July 1, 1985  
ST-HL-AE-1296  
File No.: G4.2

•  
South Texas Project  
Units 1 & 2  
Docket Nos. STN 50-498, STN 50-499  
Meeting Notes from NRC MEB Audit  
Question Review Portion

Attachments: (1) Responses to NRC Questions 210.18 through 210.65  
(2) Presentation Slides Regarding Question 210.52  
(3) List of Attendees

Pipe Break Exclusion  
Zone for Feedwater  
(Typical)  
Q&R 210.33-2

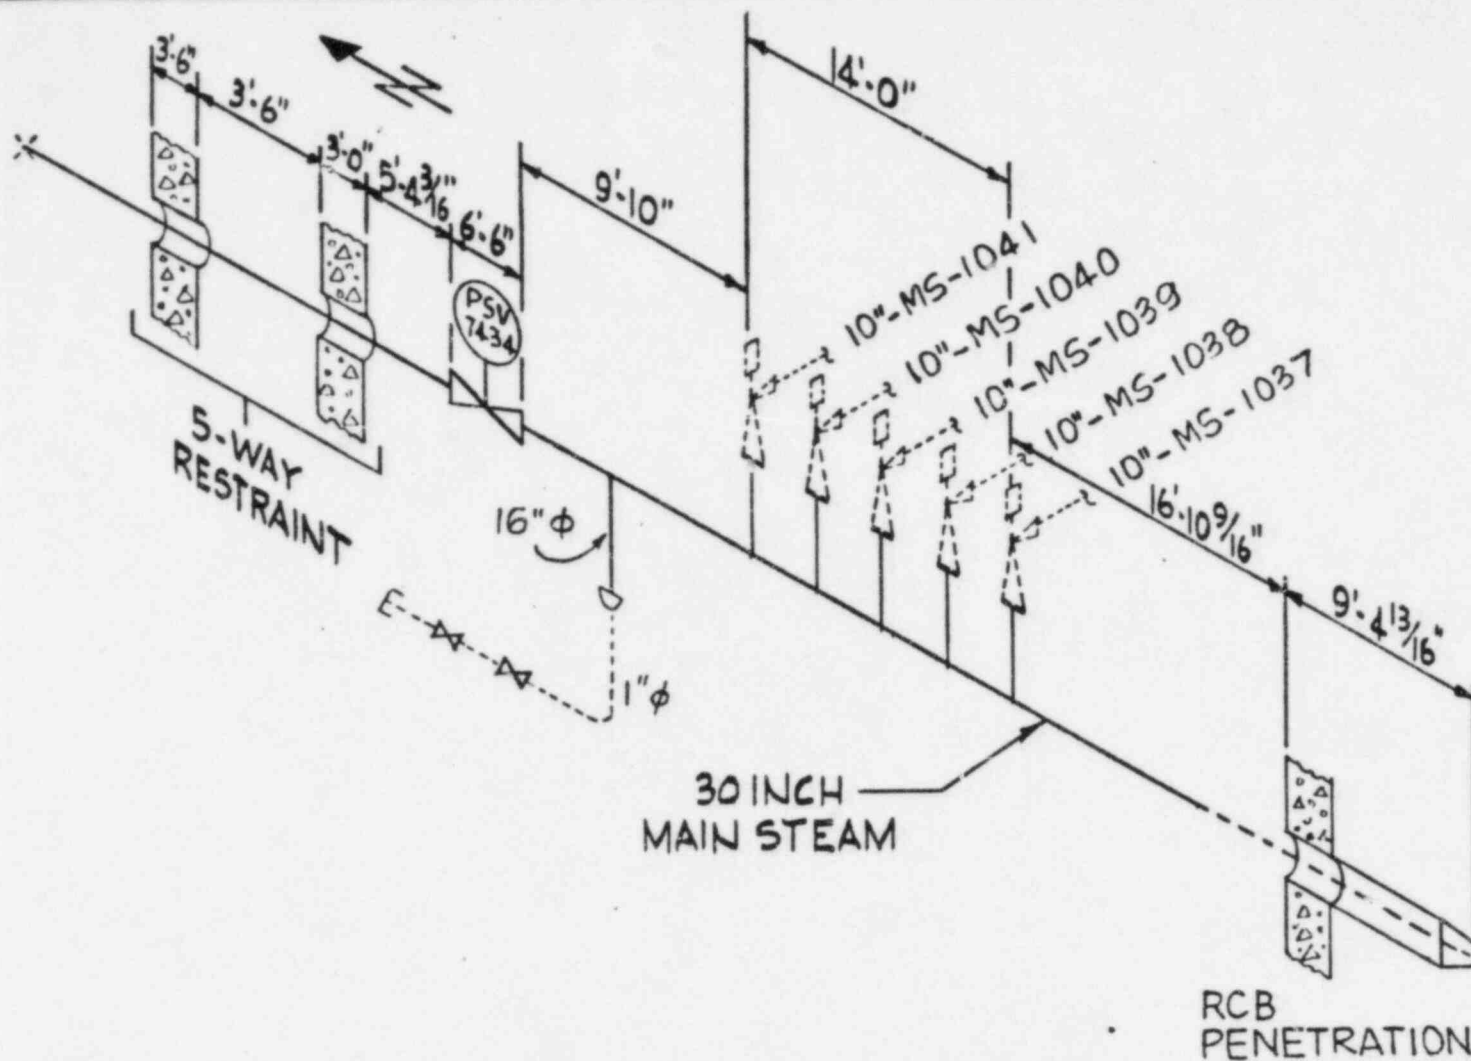
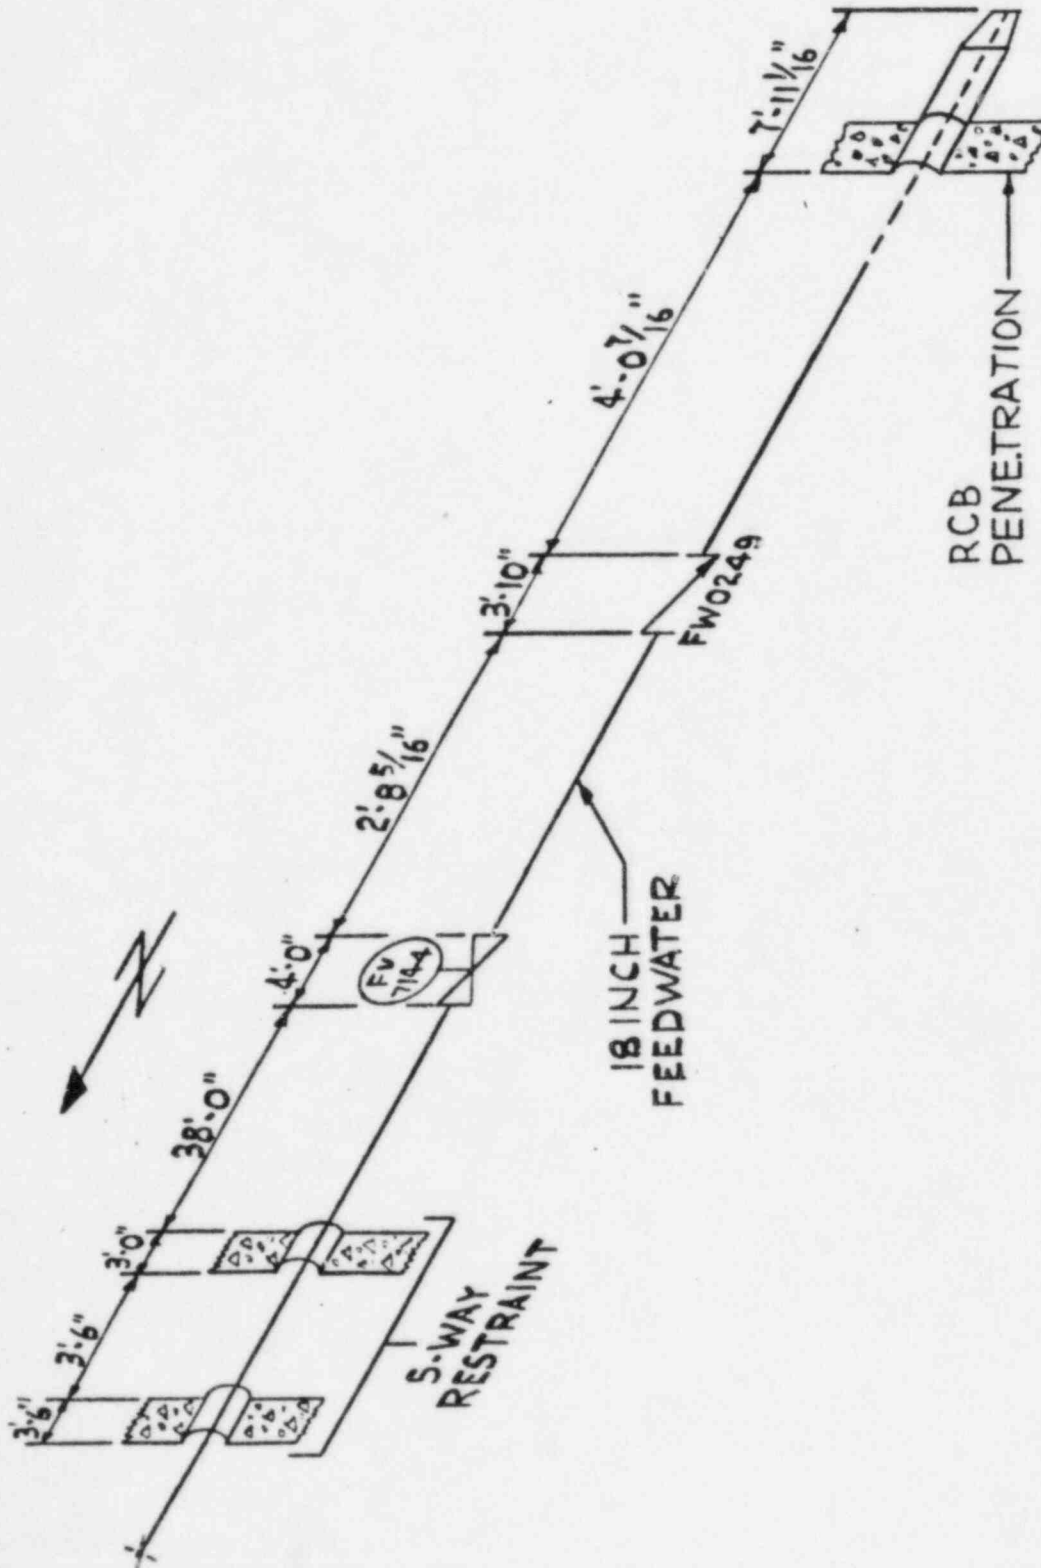
The criteria in the FSAR for designating the break exclusion zones on piping in the containment penetration areas require further justification. Identify all branch lines that are considered as part of the break exclusion zone. Provide drawings and/or other information quantifying the lengths of pipe for all systems including branch lines defined by criteria of Section 3.6.2.1.1.5 of the FSAR.

The only lines that are designated as "break exclusion zones" are the main steam and feedwater main runs in the IVC as shown on Figures Q210.33-1 and 2. The break exclusion area extends from the containment penetrations through the five-way restraints at the IVC north walls. The only branches included are the SRV lines and the short 16" diameter stubs for main steam drain and instrumentation.

FIGURE 210.53-1. Roto-Lok Closure Assembly

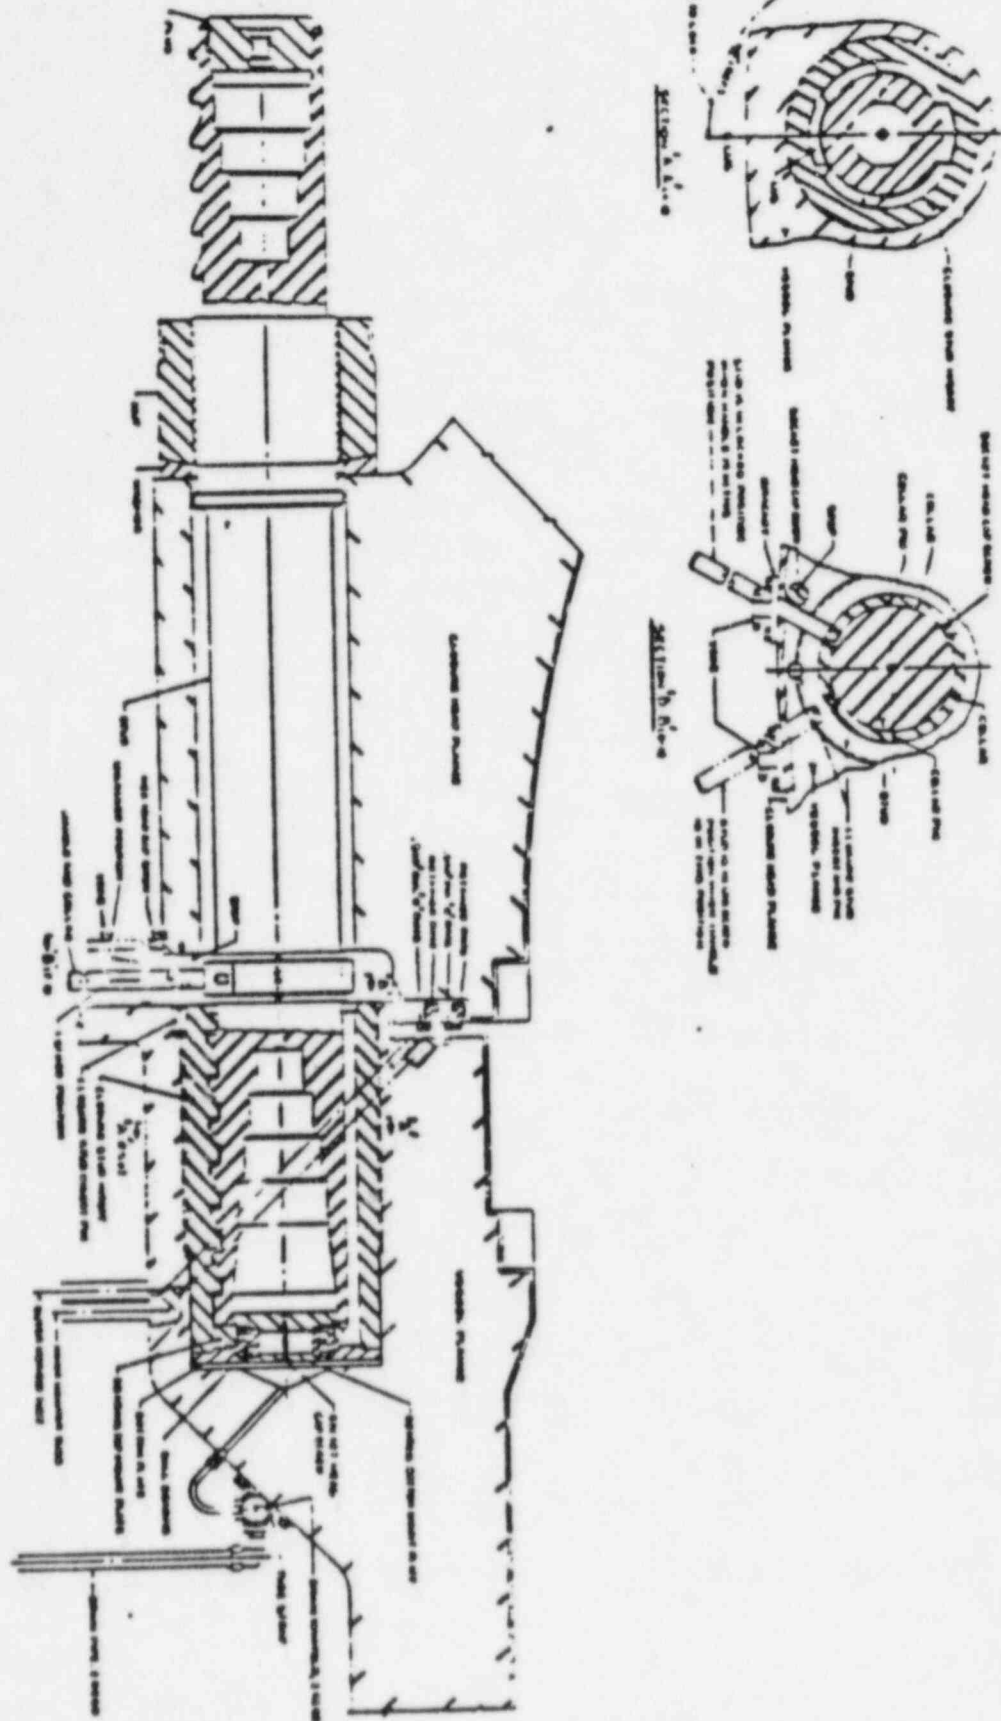
FSAR Section 5.3.1.7 describes the Roto-Lok reactor vessel head closure system which is used for the STP Units 1 and 2 reactor vessel head. it also states that a prototype Roto-Lok closure system has been tested to verify this closure design. Results of these tests are presented in the WCAP-8447, December, 1974. However, Section 7 of WCAP-8447 states that, "Also, it should again be noted that the program described in this report was for development hardware and testing only. The final design and analysis for a particular vessel is performed by the vessel supplier when the Roto-Lok is actually applied by production vessels." The staff's review of the WCAP-8447 as provided in the letter from J. F. Stoltz to C. Eicheldinger dated September 2, 1977, determined that WCAP-8447 provides an acceptable basis for the preliminary design of the Roto-Lok closure system. Furthermore, in that evaluation, the staff required that for the first reactor vessel to use this closure system (South Texas Plant) the results of final design and analysis of the closure system be provided in the FSAR. The applicant is requested to provide this information. Include in your discussion how the assumptions presented in the WCAP-8447 are applicable to the STP Units 1 and 2 plant specific reactor vessels.

The STP reactor vessel Roto-Lok closure system configuration is shown in Figure 210.53-1. This closure assembly used the sawtooth lug design discussed in Chapters 6 and 7 of WCAP-8447 (proprietary) with the following modifications:

The results of the vessel vendor's analysis of the Roto-Lok stud assembly are presented along with the corresponding ASME code allowables in the following table. This table shows the code allowable limits are met.

<u>Category</u>	<u>Governing Value</u>	<u>ASME Code Allowable</u>
Design Stud Membrane Stress Intensity	34.73 ksi	34.8 ksi
Maximum Average Stud Service Stress Intensity	54.3 ksi	84.0 ksi
Maximum Stud Service Stress Intensity	76.8 ksi	126.0 ksi
Usage Factor	0.502	1.0

FIGURE 3-1 DESIGN DIFFERENCES BETWEEN 4-XL AND 4-LOOP STANDARD (412) LOWER INTERNALS

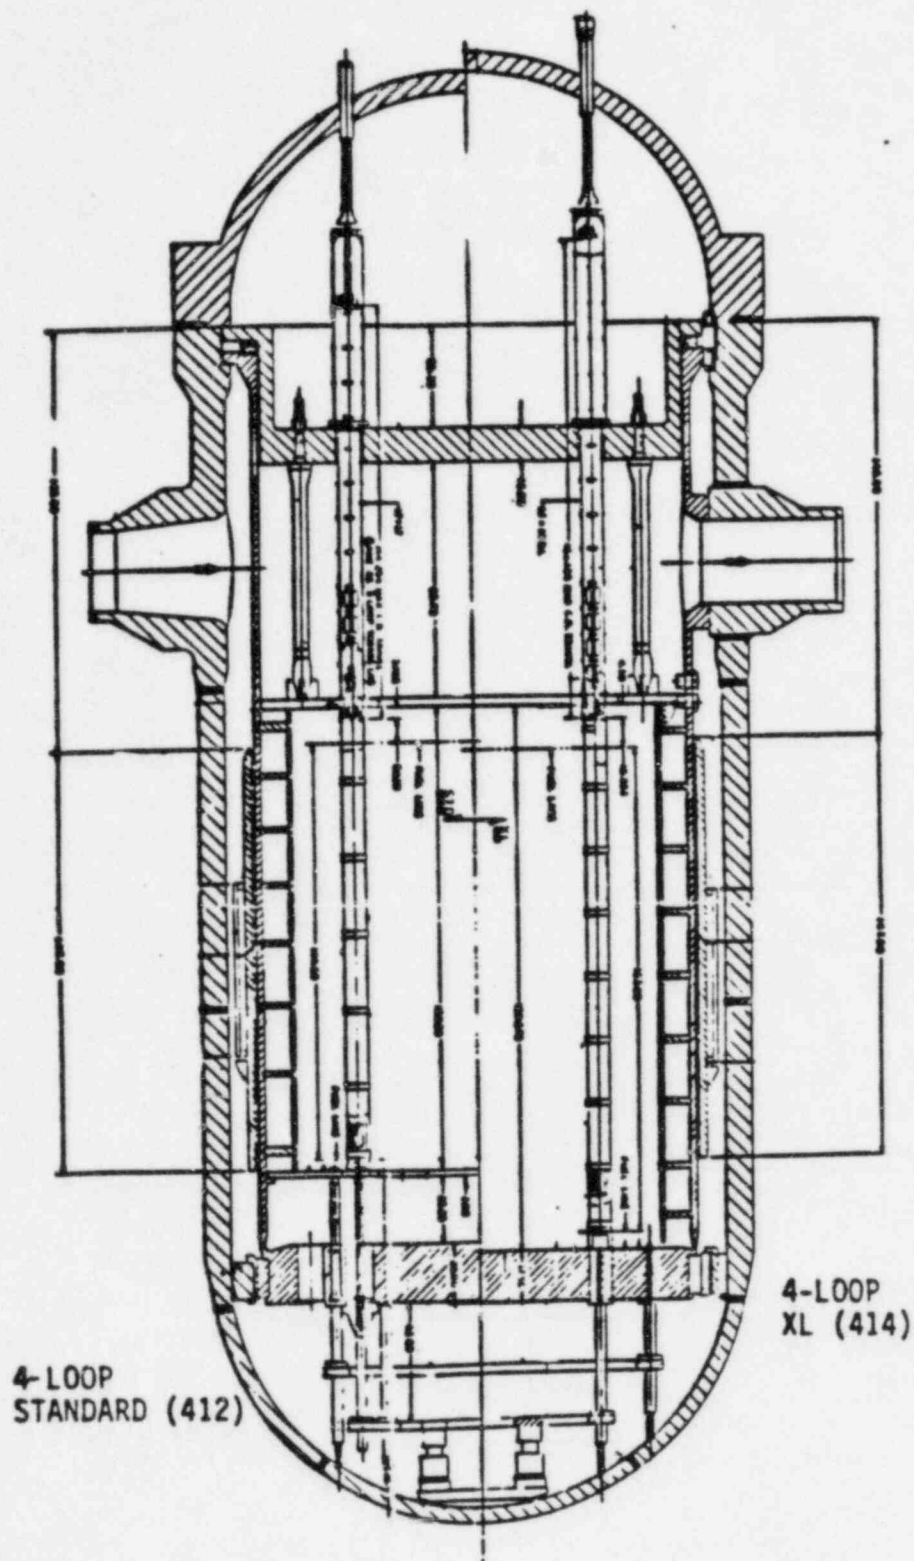
FSAR Table 1.3-1, Comparison with Similar Facility Design, states that the new design of the reactor vessel head closure system and lower internals are different from the Comanche Peak plant. Provide additional information which describes the differences in lower internals design between STP and Comanche Peak. Specifically, describe any changes in the reactor internals design which may have resulted from utilization of the rapid Refueling concept at STP. If such changes exist, discuss the effects of these changes on the response of the reactor internals to flow-induced excitation and provide the basis for meeting the guidelines of Regulatory Guide 1.20 and maintaining Indian Point, Unit 2 as the prototype plant for STP.

No changes were made to the South Texas reactor internals resulting from the utilization of the rapid Refueling concept that would impact the vibratory response of the internals. The utilization of lifting rods in the upper internals to facilitate the removal of the upper internals with the upper head has no impact on the internals vibratory response. In fact the vibration assessment, based on flow turbulence, is only concerned with the region below the upper support plate in the lower guide tube region, inlet nozzle, downcomer and outlet nozzle locations.

The South Texas plant is based on the four loop NSSS design of Indian Point insofar as Regulatory Guide 1.20 is concerned. In addition, the South Texas plant incorporates such design enhancements as have already been reviewed and approved by the NRC staff such as neutron pads versus thermal shield and the inverted top hat design. One additional modification concerns the change to the reactor internals to permit the use of a 14-foot core. To account for this the fuel no longer rests on a lower core plate but simply rests on the lower support plate. An analytical flow-induced vibration assessment has been performed and documented for the South Texas plant. It has been concluded that the vibrational response of this plant obtained from scale model tests and instrumented plant tests, shows that the internals vibration levels are low and that the South Texas reactor internals design is adequate to assure structural integrity against flow induced vibrations.
